W3F1-2001-0085
A4.05
PR

Subject: Waterford 3 SES
Docket No. 50-382
License No. NPF-38
Emergency Plan Implementing Procedures

Included in this submittal are the following procedures:

OSC FLOORPLAN AND EQUIPMENT LOCATIONS

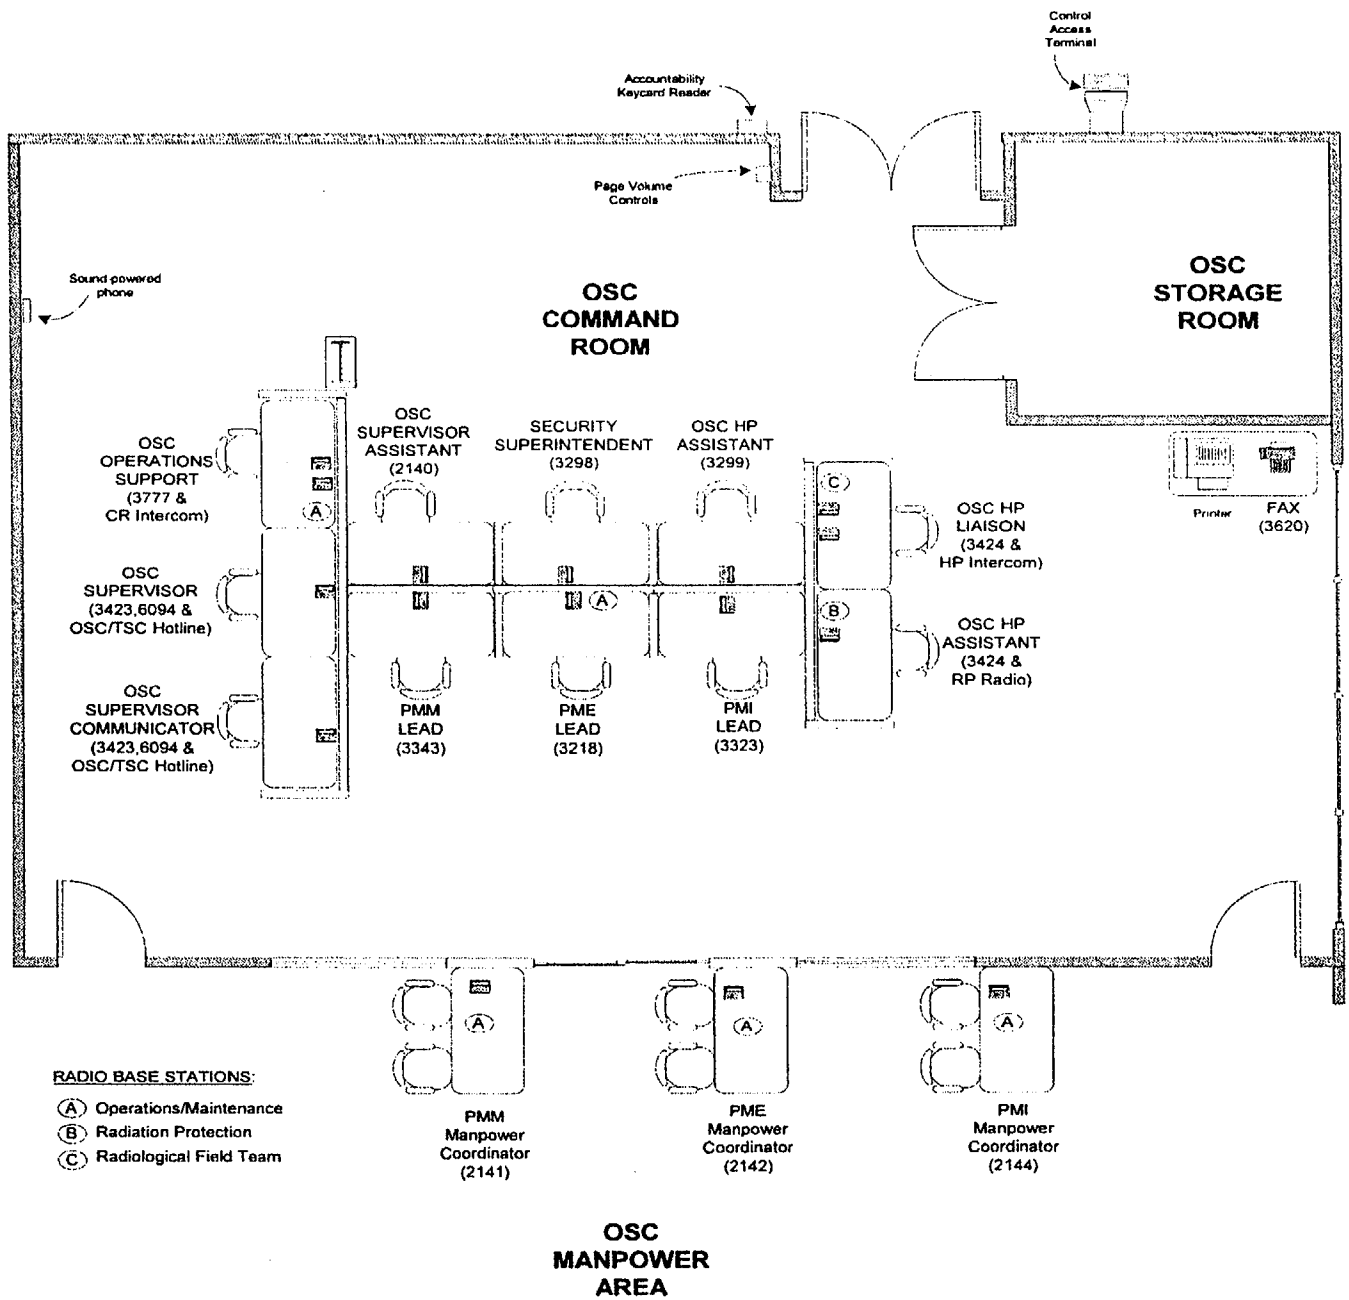
Revised procedure to reflect enlargement of the OSC Command Room and OSC Storage Room.
